Response to the CSELR Planning Modification Report (SSI-6042)

City of Sydney
Town Hall House
456 Kent Street
Sydney NSW 2000

December 2014

Figure 3.3 Proposed modification to the Grosvenor Street stop

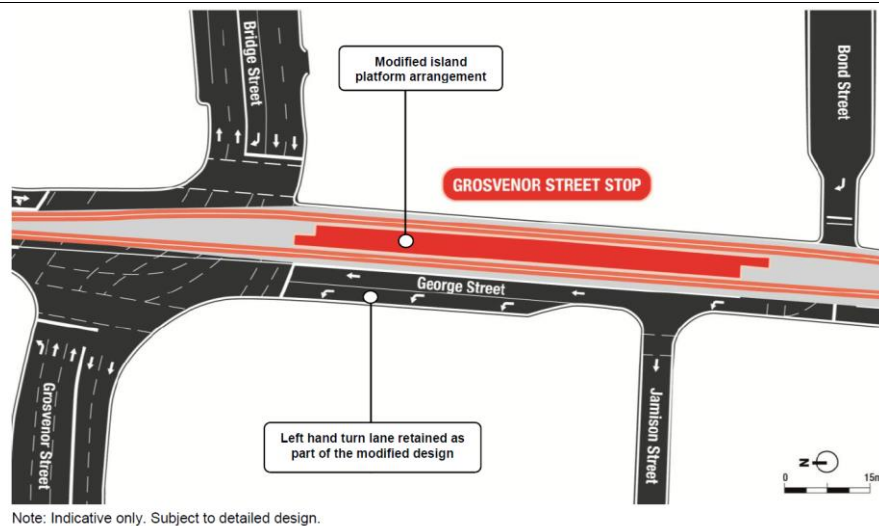
The new arrangement does not provide the following:

- Reduced functionality of the stop, as there will be no direct passenger access to the platform from the eastern footpath, which will be subject to the highest passenger load (in the PM peak);
- No additional footpath width for eastern and western footpaths;

The City's preference is to maintain a side platform arrangement wherever possible for overall network consistency and wayfinding legibility and to reinforce the view corridor that already exists along George Street. The City is also concerned that the island platform does not allow for future proofing of a larger pedestrian environment.

In addition, footpath widths must not be reduced below the widths specified in Clause 1.6.9 of Schedule 7 - Technical Requirements of the Development Agreement that TfNSW has entered into with the City of Sydney.

Delete proposed left hand turn from George St to Grosvenor St;

Revert to previously approved side platform arrangement;

Widen eastern and western footpaths on George St as previously approved;

Comply with minimum paving widths as per Clause 1.6.9 of Schedule 7 - Technical Requirements of the Development Agreement.

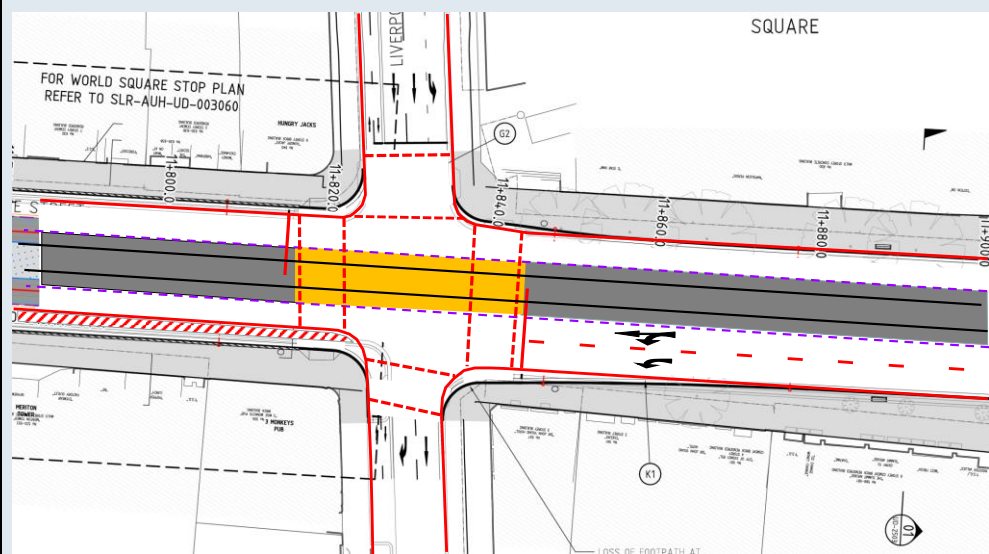
The City supports removal of the World Square platform provided footpaths on the eastern and western sides of George Street from Liverpool Street to Bathurst Street are widened.

Below shows the possible footpath improvements (in red) that the City is seeking to be included as conditions following the elimination of the World Square stop, in addition to the proposed widening along both sides of George St between Wilmot and Bathurst Sts.

Additional footpath width in George Street.

Additional footpath width (retains south/west corner alignment and reduced pedestrian crossing distance).

Widen pavements as shown in above sketches, in addition to the proposed widening along both sides of George St between Wilmot and Bathurst Sts.

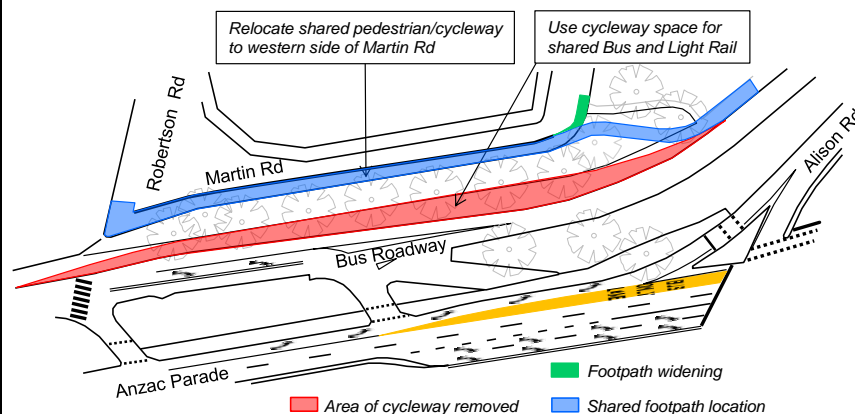
Tay Reserve is not realistic given the highly negative impact caused by the removal of trees near Martin Rd and Robertson Rd.

The City considers that the design from the shared section of the bus and light rail corridor south of Robertson Road and around to Alison Road must be reconsidered to have no or less impact on the trees.

If the design cannot accommodate bus roadway, light rail and shared pedestrian/cycleway path without impact on the trees, then an option would be to relocate the pedestrian/cycleway path to the western side of Martin Rd. This will allow the use of the additional pedestrian/cycleway space as part of the shared section of bus and light rail.

There would be a loss of parking which can be recovered by introducing some angle parking in the wider sections of Robertson and Martin Roads.

Redesign the shared section of the bus and light rail corridor south of Robertson Road and around to Alison Road to have no or less impact on the trees, investigating the option to relocate the pedestrian/cycleway path to the western side of Martin Road;

Figure 5.1d (Extract) - Key features of the CSELR proposal, page 5-5, EIS Volume 1A

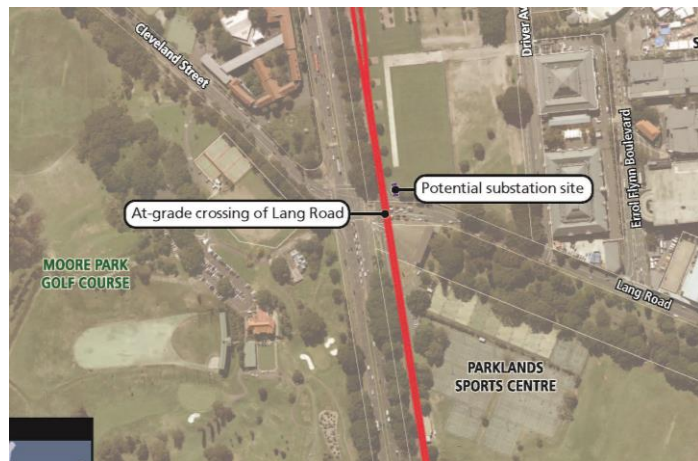
Table 4.2 of the Submissions Report, Volume 1 on page 4-9 stated: “Preference for below ground substation at Moore Park or integration with new amenities building near tennis centre”, with Figure 6.2d (image below) of the same volume of the Submissions Report, on page 6-6 showing the proposed substation on the southern side of the intersection of Lang Road and Anzac Parade. This is contradictory as the image shows one location and yet the table gives two options.

Figure 6.2d (Extract) - Key features of the revised CSELR proposal, page 6-6, Submissions Report Volume 1

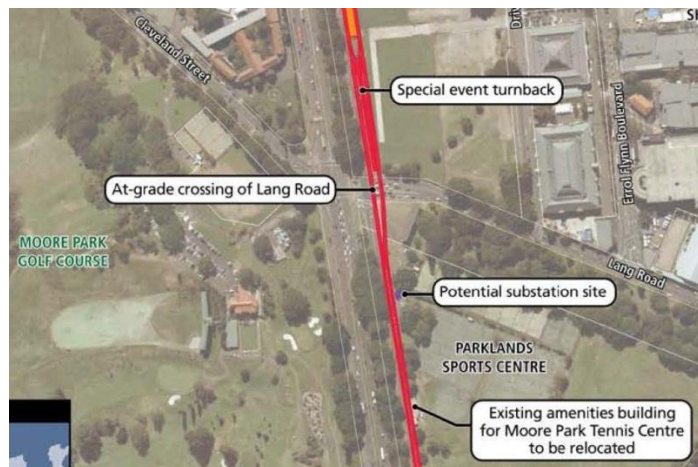
Given above City considers that no location has been approved for the Moore Park East substation given.

<p>Figure A - City of Sydney's Stormwater Drainage System at Moore Park between Lang Road and Roberston Road – grey shows area potentially impacted by any above-ground substation</p> <p>If the proposed substation is constructed next to the new amenities building, it would be located over this stormwater drainage box culvert. The box culvert could be reaching its life expectancy and it was not design to accommodate the load that the substation would transfer to it. This could have serious consequences for its structural integrity, affecting the new substation, making future maintenance and repair operations difficult and significantly more expensive for the City.</p> <p>The City of Sydney opposes the construction of the substation near the amenities building and recommends the construction of the underground substation near the southern side of the intersection of Lang Road and Anzac Parade as presented in Figure 6.2d of the Submissions Report Volume 1 (above).</p> <p>RECOMMENDATION 11: That the Moore Park East Substation be located near the southern side of the intersection of Lang Road and Anzac Parade as presented in Figure 6.2d of the Submissions Report Volume 1.</p>

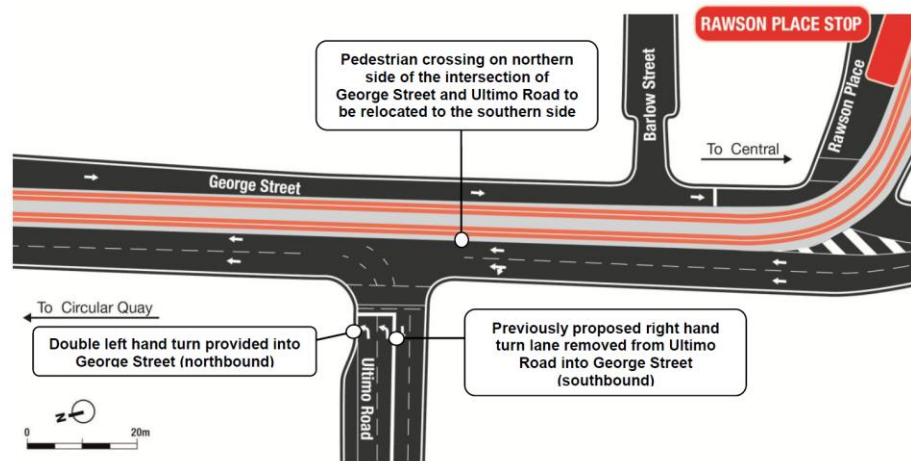
<p>Additional issues the City wishes to raise</p>
<p>George St/Ultimo Rd intersection</p>	<p>The proposed relocation of the pedestrian crossing in George Street from the northern side of Ultimo Road to south of Ultimo Road will maintain pedestrian access. The modified design bans the right turn from Ultimo Road to George Street (East to south) which will restrict local access and divert traffic to Harris Street via Ultimo Road. The City has no objection to this.</p>

However, the Harris Street and Ultimo Road intersection is already heavily congested especially in the evening peak period. In addition, it is expected there will be additional traffic on Sussex Street heading to Harris Street via Ultimo Road. The change to restrict the right turn to George Street will add to the congestion at the intersection of Harris St and Ultimo Rd.

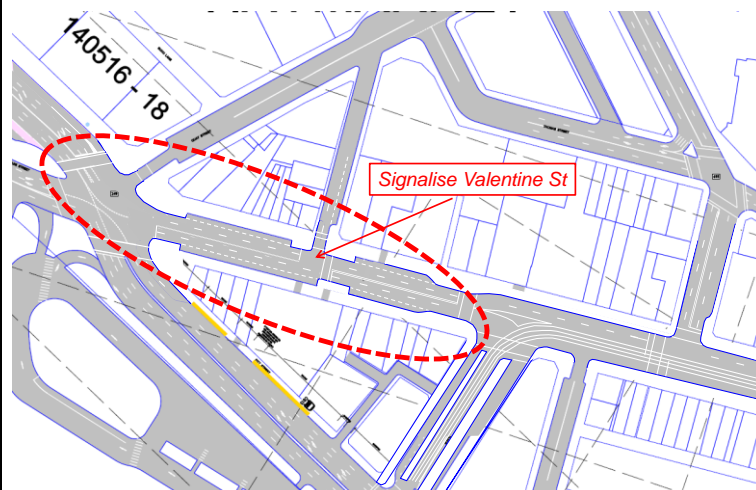
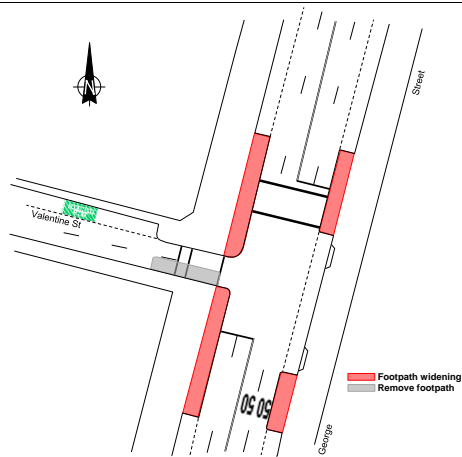
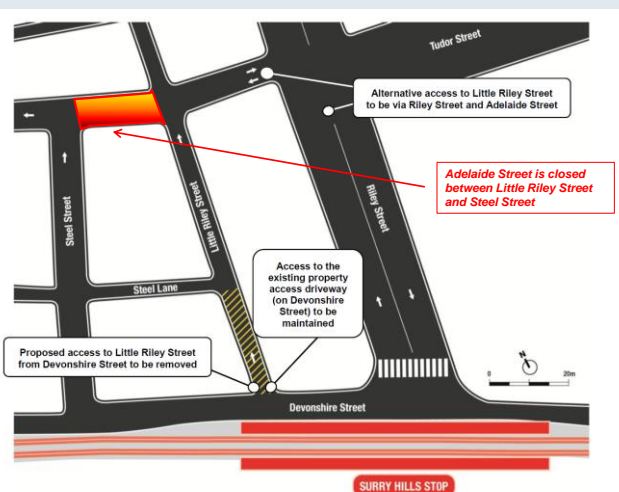
The concept sketches below illustrate footpath widening and possible traffic signal changes.

Traffic signals to provide right turn from Valentine Street to George Street to travel south and east.

Signalise Valentine St to allow a right hand turn to travel south along George St by relocating the existing pedestrian signals in George Street near Valentine Street to the intersection of Valentine Street;

Undertake footpath widening at the George Street/Valentine Street intersection.
